**STAFF RECOMMENDATION**  
**2007 Cedar Lane**  
**February 20, 2013**

**Application:** New construction—addition; Partial Demolition—rear dormer  
**District:** Belmont-Hillsboro Neighborhood Conservation Zoning Overlay  
**Council District:** 18  
**Map and Parcel Number:** 11703005300  
**Applicant:** S. Mitchell Hodge, AIA  
**Project Lead:** Melissa Baldock, melissa.baldock@nashville.gov

RENOVATIONS AND ADDITIONS TO  
**2007 CEDAR LANE**  
Nashville, TN 37212

Figure 6. Left gable field siding.

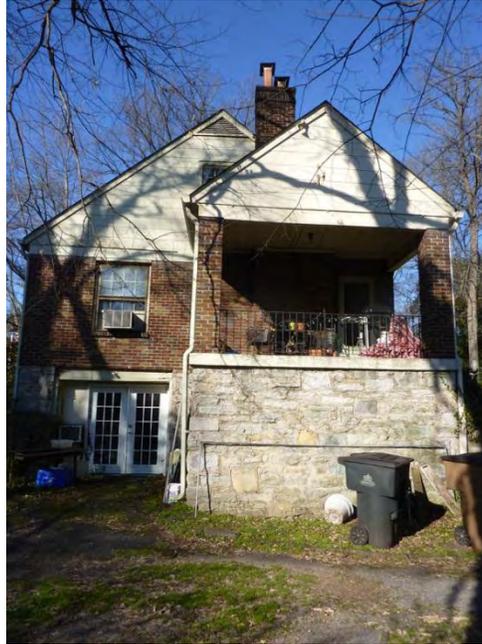
Materials: The existing house is brick with a stone foundation and siding accents in the gable fields and in the dormers (See Figures 5 and 6). The applicant is proposing to remove the siding from the gable fields and replace it with stucco and battens. Although in a conservation overlay, the Commission does not regulate the modification of accent materials like this, staff encourages the applicant to retain the siding in the gable fields. Siding is a more historically appropriate material than stucco and battens. Stucco and batten elements are typically seen on Tudor-style houses and other houses that were built in the 1920s to the early 1940s. Siding is more historically appropriate on a house like this one, which dates to the early to mid 1940s and is minimal traditional style with Colonial Revival elements. Similarly, the applicant is proposing to replace the siding on the dormers with stucco, and staff encourages the retention of this siding.

1. Staff review and approve a brick sample, a stone sample, the asphalt shingle color, and window and door specifications
2. The applicant consider retaining the siding material in the historic house's gable fields and on the dormers.
3. The applicant consider leaving the brick unpainted or using a stain if the brick is damaged.
4. The utilities be located at the back of the house or on a rear façade, beyond the midpoint of the historic house.

**SD-0**

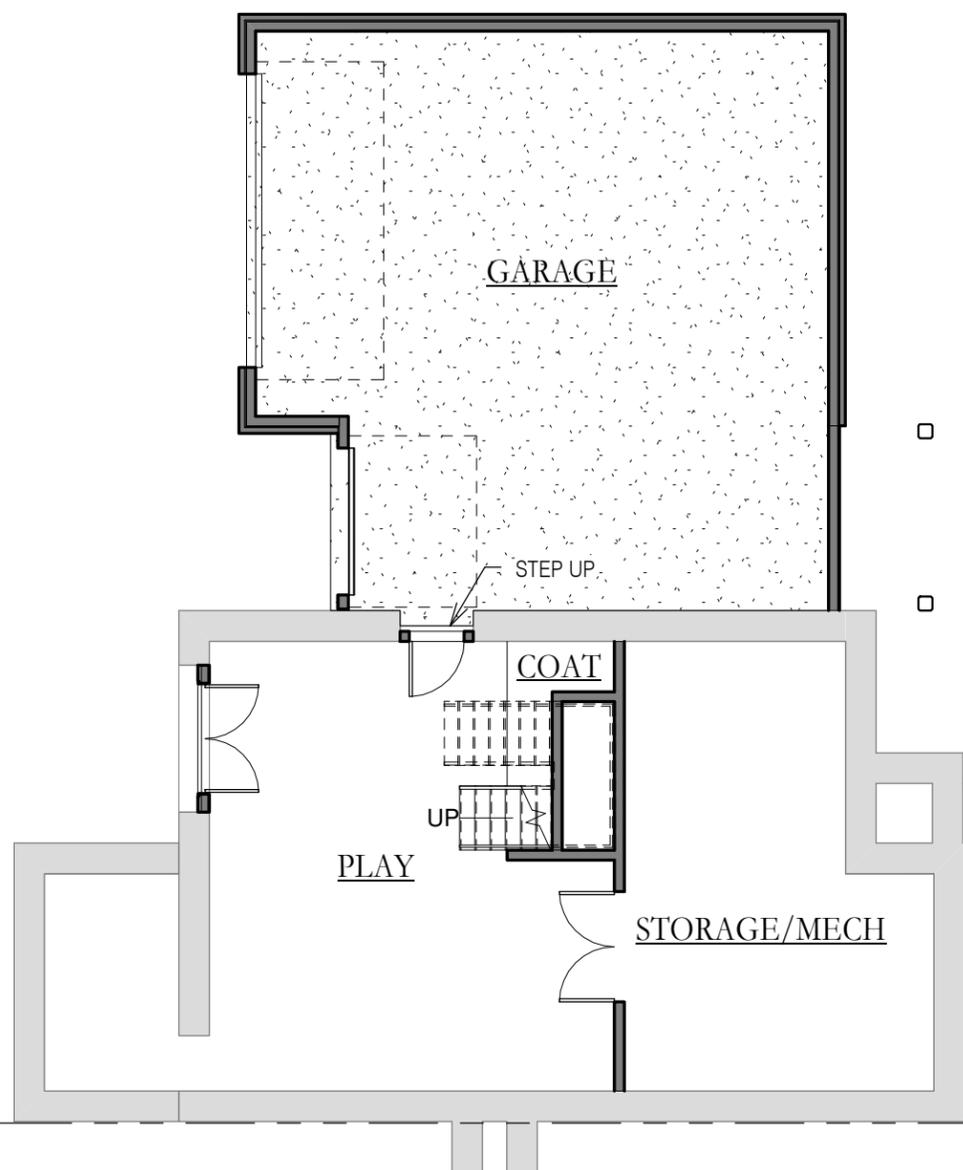
Location, Setback: The proposed addition is located entirely behind the existing house and meets all base zoning requirements for setbacks. Staff therefore finds that the

The existing house is fifty-two feet (52') wide at the front, including a covered side porch, and is twenty-seven feet, eleven inches (27'11") deep. The addition will have a maximum width of thirty-three feet (33') and a maximum depth of forty-five feet, six inches (45'6"). Although the addition will more than double the depth of the historic house, staff finds it to be appropriate because the house is shallow and because the lot is unusually deep, with a depth of over three hundred feet (300').

Attached Garage: An attached garage is proposed for the addition. The design guidelines state that an attached garage can be appropriate when "*the location of the attached garage is in the general location of an historic accessory building, the new garage is located in the basement level, and the vehicular access is on the rear elevation.*" In this instance, the garage is located at the basement level, and is located towards the back of the house, over one hundred and thirty feet (130') from the street. It is in a location where a historic accessory structure would have been located. However, vehicular access is on the left façade, not the rear façade. Staff finds the location of the vehicular access to be appropriate because it is located three feet, three inches (3'3") behind the back wall of the house and is inset from the line of the side porch by approximately thirteen feet (13'). This inset, plus the fact that the garage will be located over one hundred and thirty feet (130') from the street will help reduce the visual impact of the attached garage. The garage will be accessed via an existing curb cut and driveway, which will be extended (see Figure 7).

ELEVATIONS  
**SD-2**  
PROJECT 1313  
DATE: 02.05.13

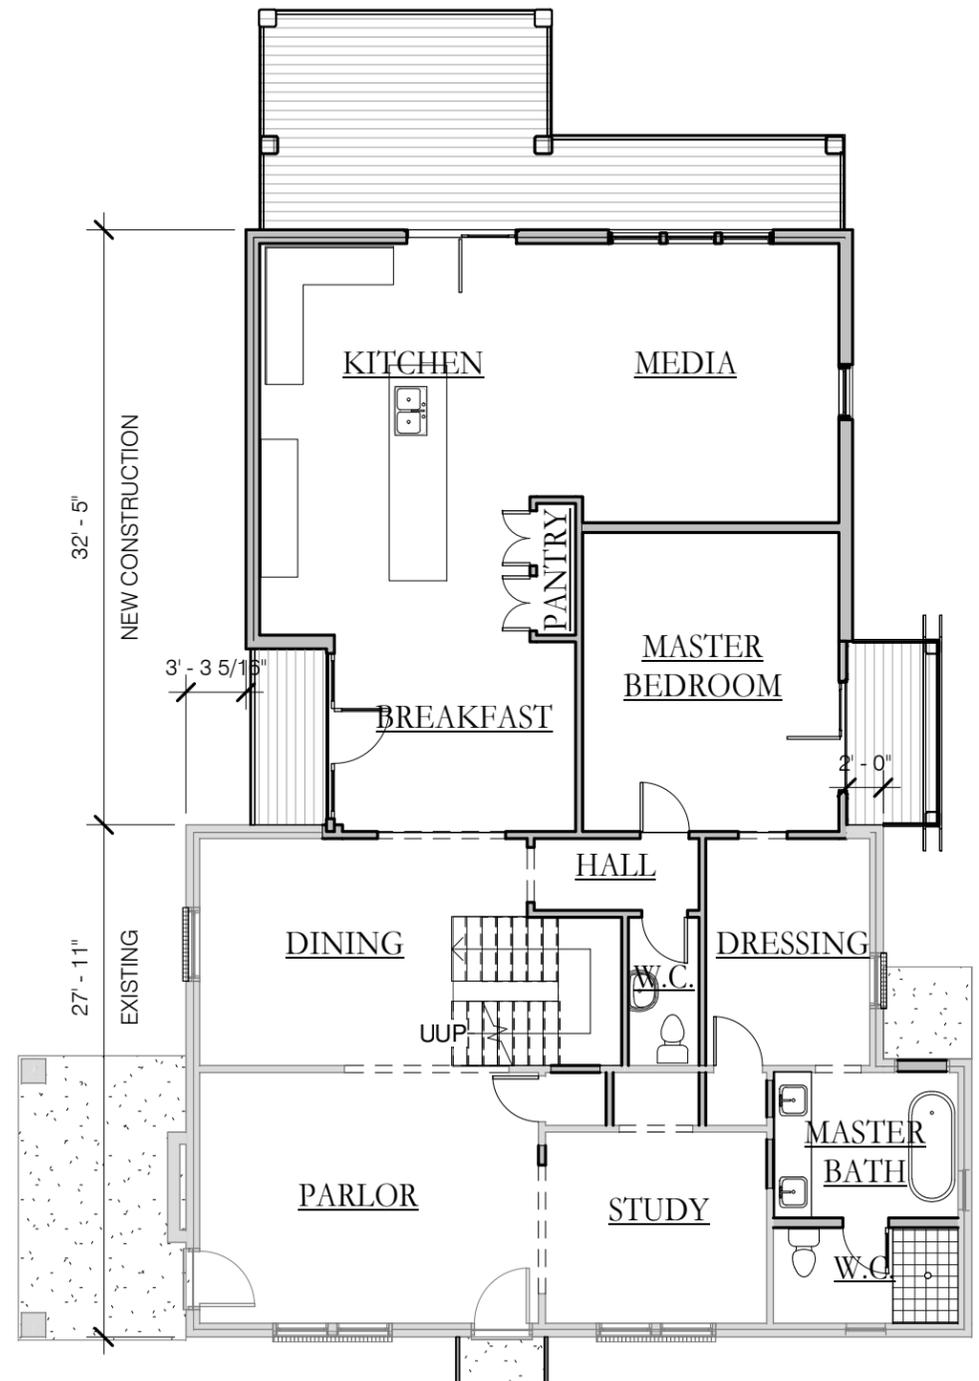
Height, Scale: The site slopes down from the front of the house to the back of the house. The new addition will match the height of the existing house and will have a maximum height of approximately thirty feet (30'). The addition ties into the house's roof approximately one foot (1') below the ridge line, but later rises back up to meet the height of the house. The addition's foundation line will match that of the historic house.

The addition steps in from the side walls of the house appropriately. On the left side, the addition initially steps in seven feet, six inches (7'6") for a depth of approximately nine feet, nine inches (9'9"), but then steps back out to be inset approximately three feet, three inches (3'3") from the historic house's sidewall. The seven foot, six inch (7'6") inset on the left side will have a covered balcony on the second floor. On the right side, the addition steps in two feet (2') from the sidewall. However, at the back of the historic house, where the addition begins, there will be a two-story covered deck that extends three feet (3') beyond the back wall of the house. Staff finds this covered deck to be appropriate because the house is wider at the front on the right side, and the covered deck will be inset one foot (1') from the front wall of the house.

The drawings indicate that the applicant is proposing to paint both the historic brick and the brick on the addition. In a conservation overlay like the Belmont-Hillsboro district, the Commission does not regulate the painting of brick. However, staff discourages the painting of previously unpainted brick because it can cause long term damage and deterioration to the historic material. In addition, painting of the brick increases the maintenance responsibilities for the owner. If the brick needs to be painted because of damage, staff recommends the use of a stain for the brick, or that the brick be painted a color that closely matches the historic brick color.

**Roof Form:** The existing house's primary roof form is a side gable with a slope of 10:12. The addition's primary roof form will also be a side gable with a slope of 10:12. On the left elevation, there will be a gabled dormer with a roof slope of 10:12. On the right and rear elevations, there will be shed dormers with a roof slope of 3:12. Staff finds that the
